Consultee Comments - Urban Design

Consultee:	BNE – Urban Design
Reference Number:	23/03204/OUT
Proposal:	Outline application (with all matters reserved) for the demolition of existing buildings and structures and redevelopment of the site for a new local centre (E (a-f), F1(b-f), F2(b,d)), open space and employment (office and laboratory) floorspace (E(g)(i)(ii) to the ground floor and employment floorspace (office and laboratory) (E(g)(i)(ii) to the upper floors, along with supporting infrastructure, including pedestrian and cycle routes, vehicular access, car and cycle parking, servicing areas, landscaping and utilities. (The Development is the subject of an Environmental Impact Assessment)
Site Address:	Beehive Centre Coldham's Lane Cambridge CB1 3ET Cambridgeshire
Case Officer:	Cuma Ahmet
Responding Officer:	Sarah Chubb
Date:	09.11.23

Proposed outline application – Coldham’s Common

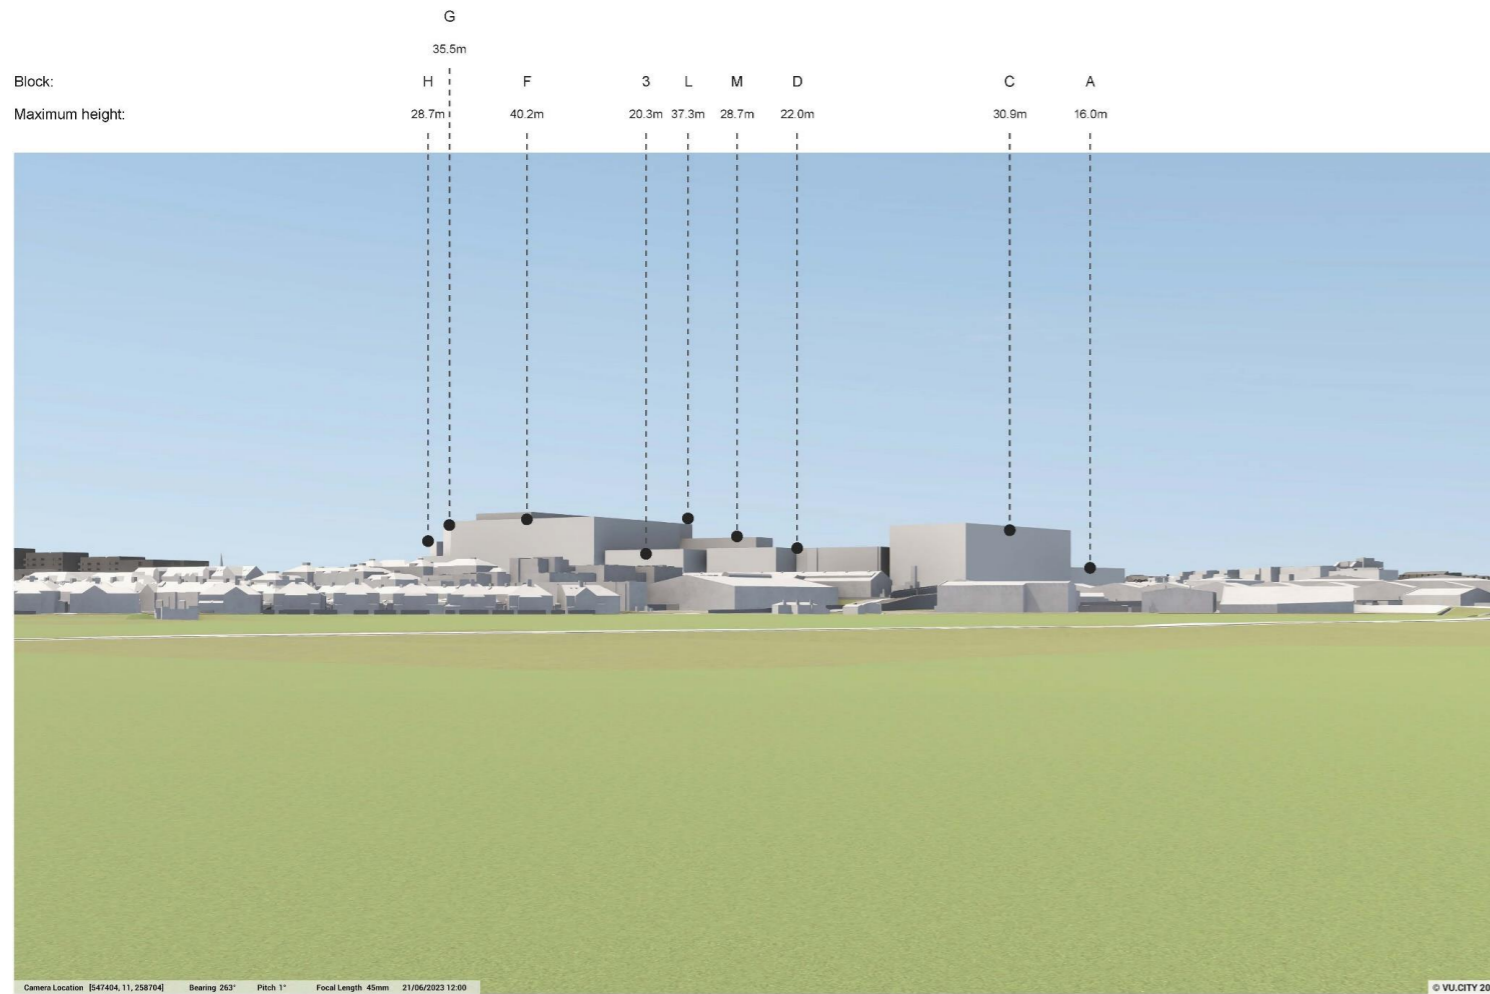
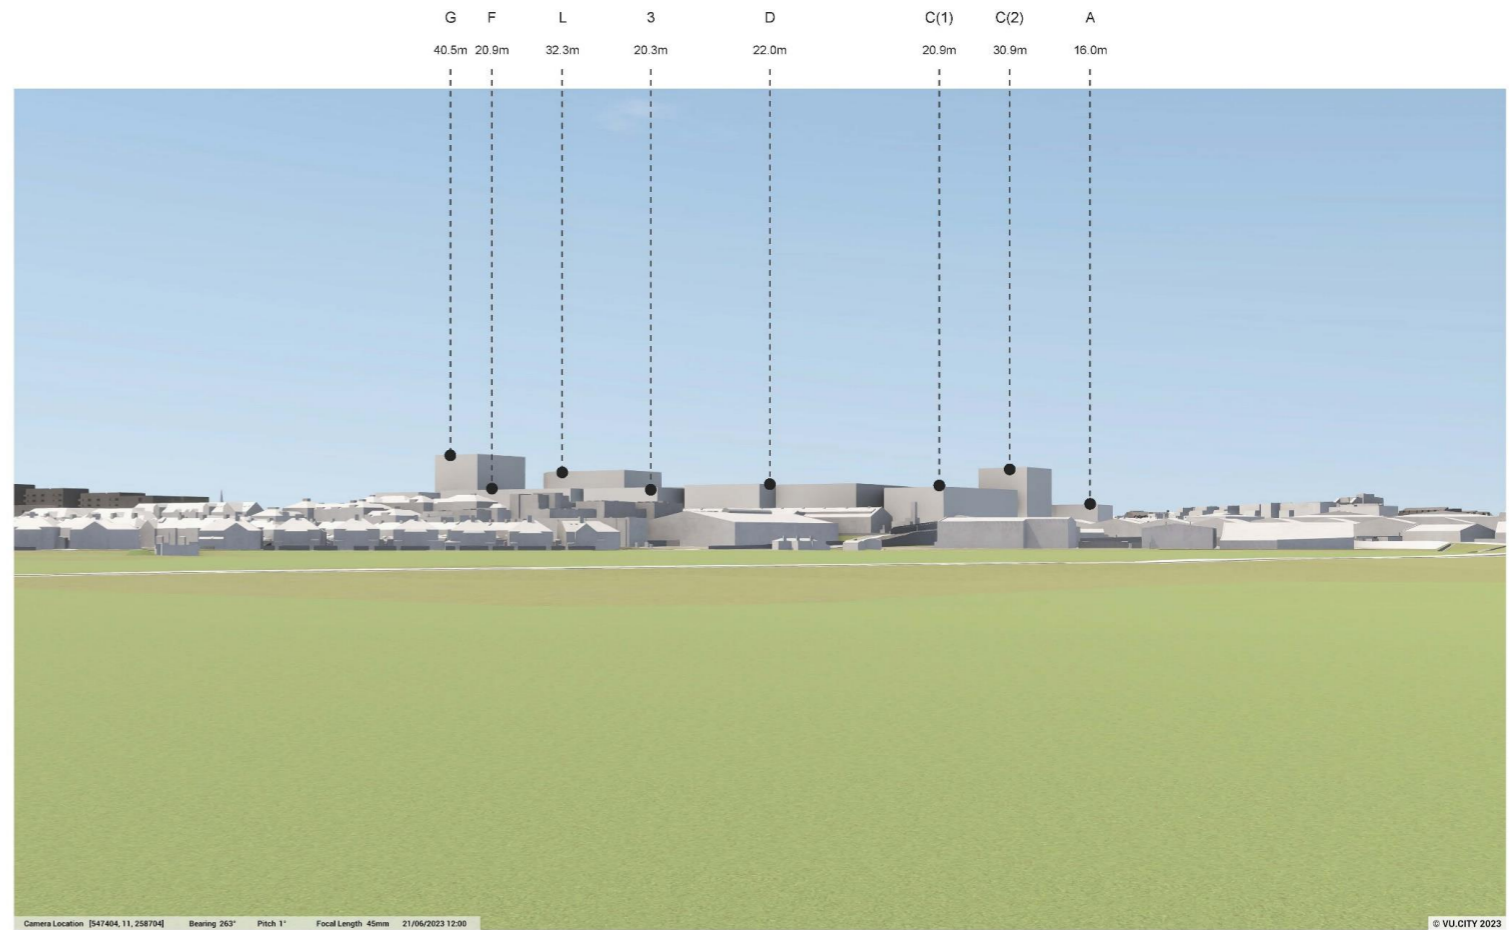
Alternative Massing Strategy - without prejudice

Proposed outline application – Castle Hill

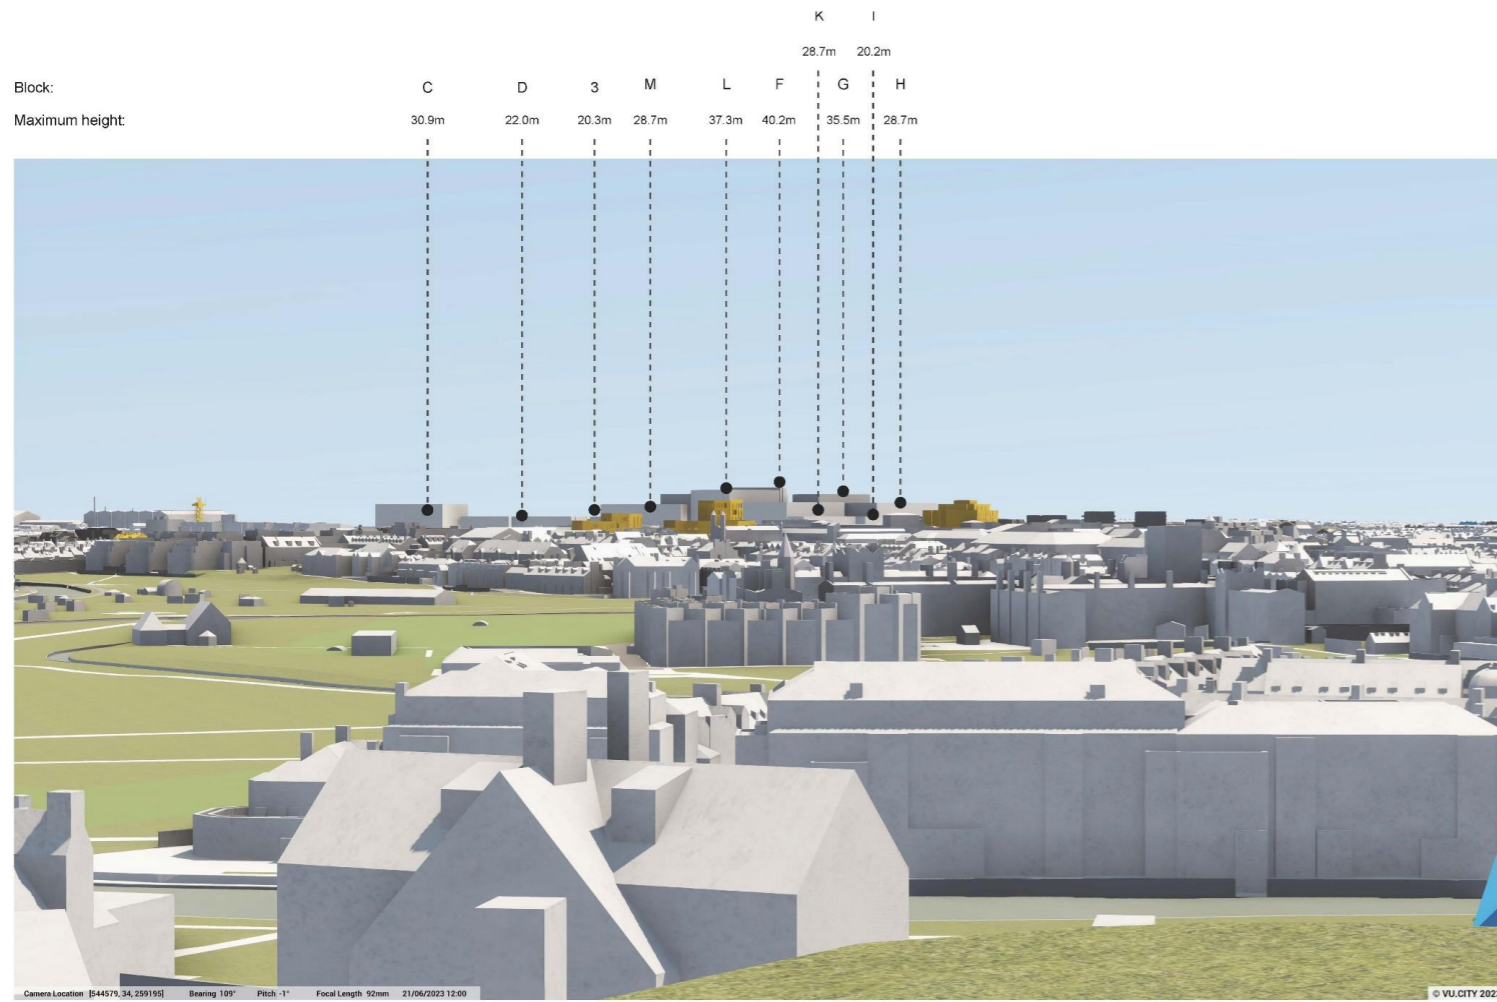
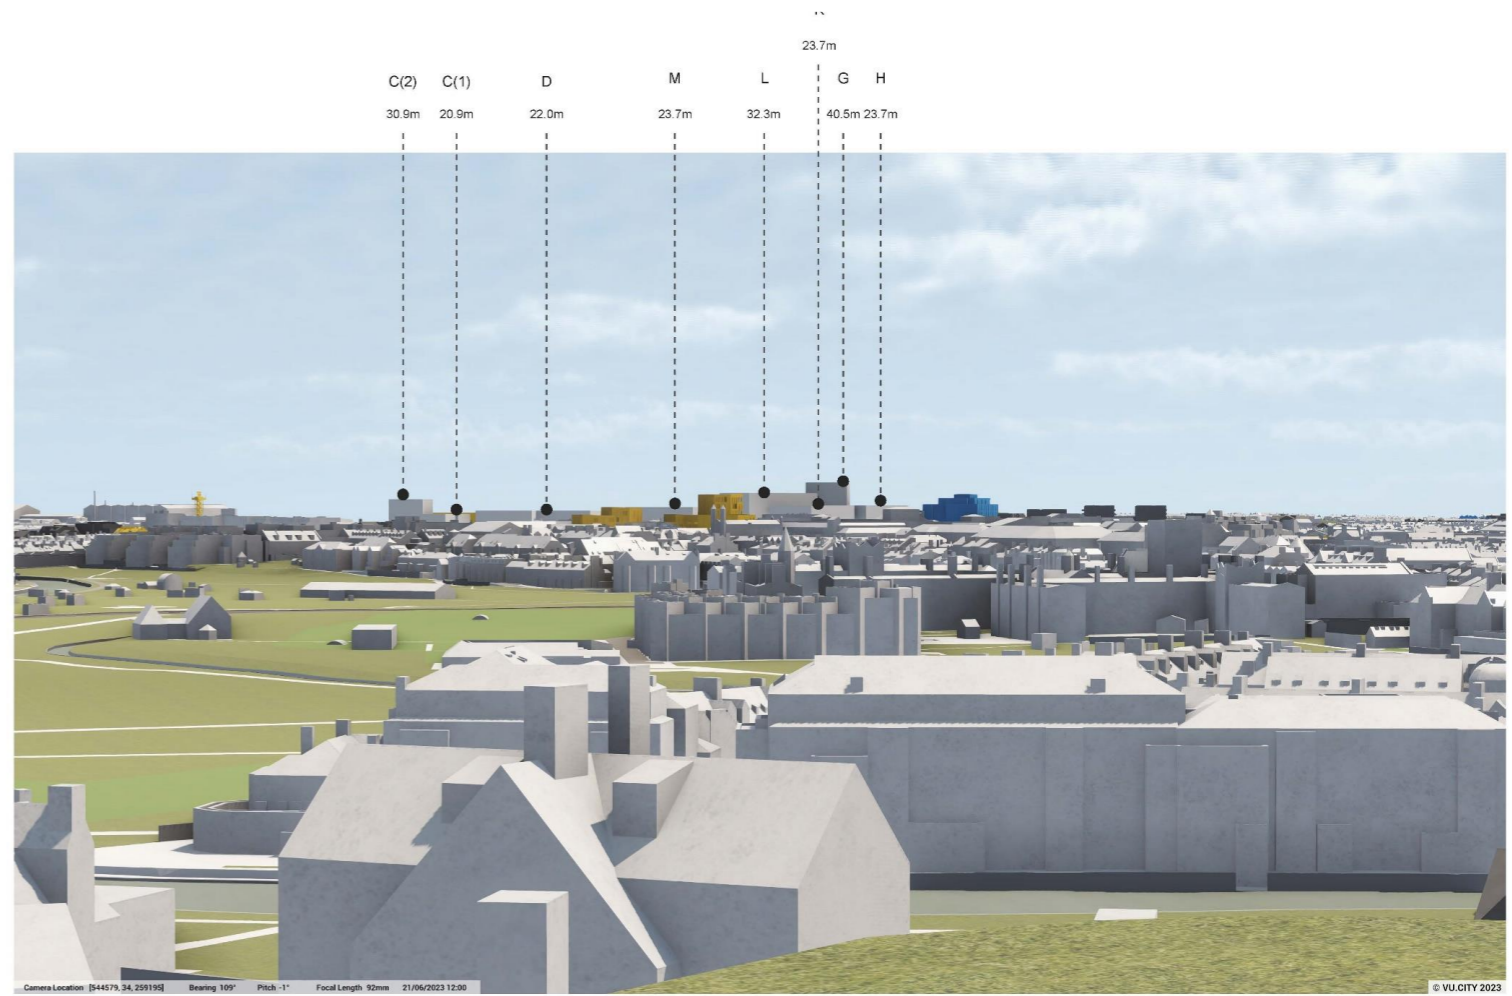
Alternative Massing Strategy - without prejudice
